MANDATORY REFERRAL NO. MR2025016 HIGHLAND VIEW ELEMENTARY SCHOOL

Description

Mandatory Referral review for a three story addition to the existing Highland View Elementary School and associated site upgrades to support the removal of existing relocatable classrooms and projected increases in enrollment.

COMPLETED: 6/16/2025

Figure 6: Pedestrian and Bicycle Deficiencies Map provided by The Traffic Group

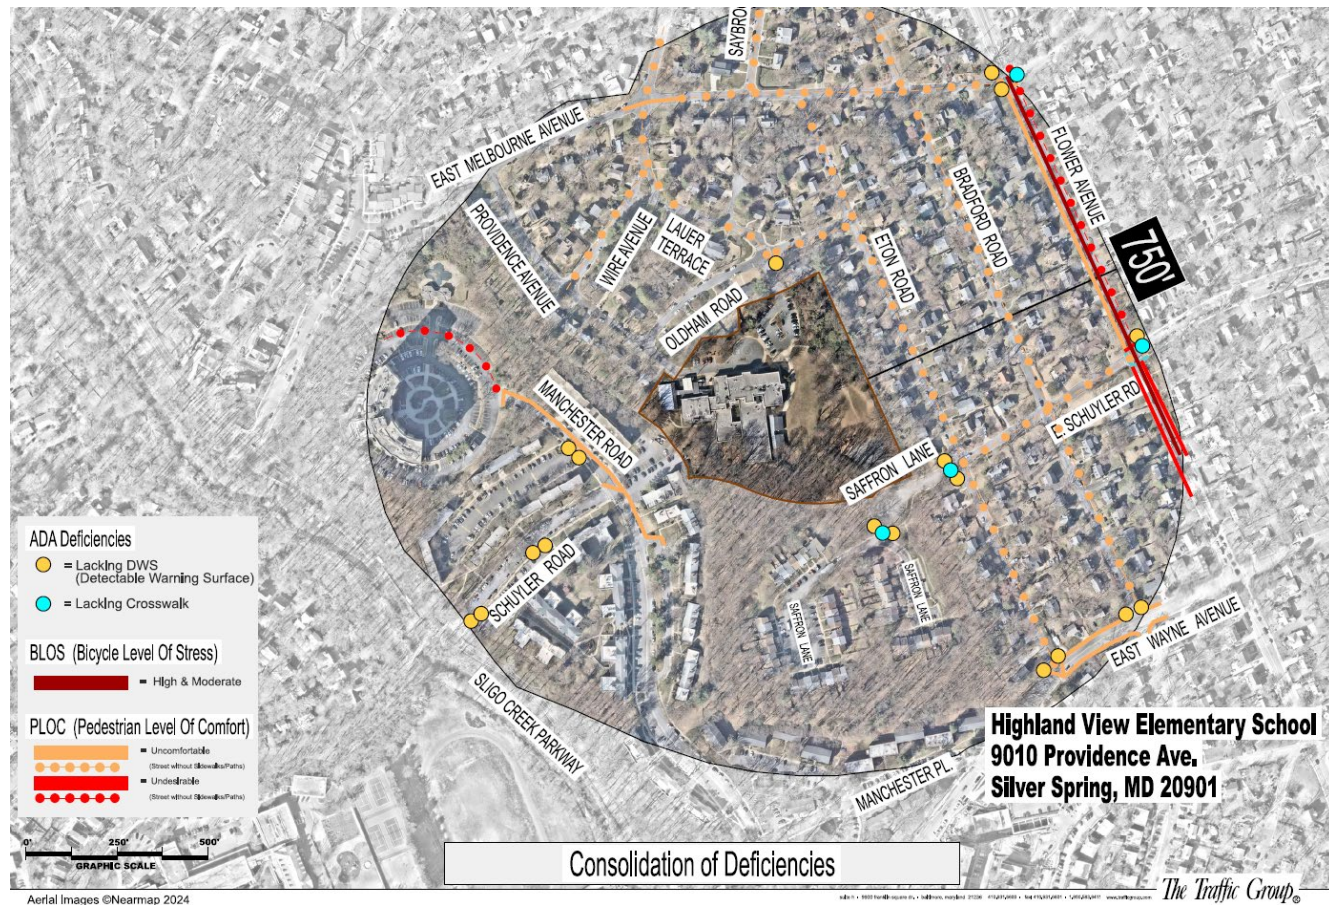
Per the LATR Guidelines, since the Project is anticipated to generate between 65-124 max net new peak-hour weekday motor vehicle trips, the pedestrian level of comfort and illuminance tests must be conducted based on a 400-foot network distance study area from all points on the site frontage, and the ADA compliance must be conducted based on a 200-foot network distance study area. Although roadways classified as local roads are not required to be studied as part of the LATR study, the Applicant did analyze some of these roadways. The Applicant also exceeded the network distance requirement by studying a 750-foot network distance for Pedestrian Level of Comfort (PLOC) analysis. Within this expanded study area, three road segments were found to have undesirable or uncomfortable PLOC scores. These include portions of Flower Avenue, Manchester Road, and East Wayne Avenue. The deficiencies are due to sidewalks adjacent to the roadway without any separation, and for Flower Avenue, a portion of the roadway that is lacking a sidewalk. For the illuminance test, the Applicant found the lighting to be inadequate along Manchester Road.

Again, the applicant went above the requirements for ADA compliance analysis and studied a 750-foot network distance. Within this study area, they observed some deficiencies that included narrow sidewalks, discontinuous sidewalks, missing or faded crosswalks, and missing detectable warning surfaces.

frontage. Within this study area, moderate and high levels of bicycle stress are found along Flower Avenue due to narrow shoulders and no signing for shared bicycle use.
